Access Compliance Report

Public Rights-of-Way

(Pedestrian Signals)

Intersection ID: N/A	Main Street:	Cross Street: N/A	Location: N/A
ADA ID: C6E2A7412464	Signal Type: Two Push Buttons-Non APS	Overall Compliance: No	Severity Score: BTN 1:N/A BTN 2: N/A No BTN: N/A
Codes/Mitigation Info/Possible Solution		Field Measurements/Component Compliance

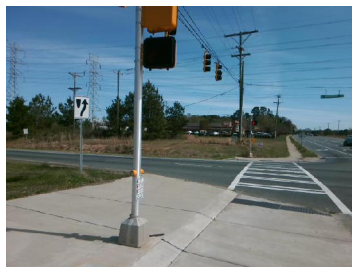
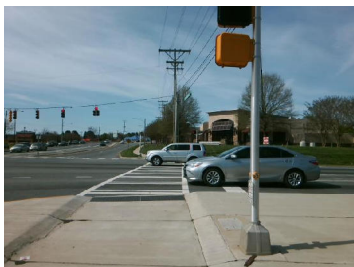
PROW/ADA: TMUTCD 4e.08, R404.2, R404.3, R404.7.3, R404.7.2

N/A	B 1 Clear Xing Direction?	Yes	N/A	B 2 Clear Xing Direction?	Yes
	B 1 Crossing Direction	To SW		B 2 Crossing Direction	To NE
Yes	B 1 DistanceTo XWalk (in)	12.0	Yes	B 2 DistanceTo XWalk (in)	48.0
No	B 1 DistanceTo Curb (in)	135.0	No	B 2 DistanceTo Curb (in)	148.0
Yes	B 1 Diameter (in)	2.0	Yes	B 2 Diameter (in)	2.0

Possible Solutions: Replace Signal Push Button With APS Button on New Post. Remove & Relocate Sign.
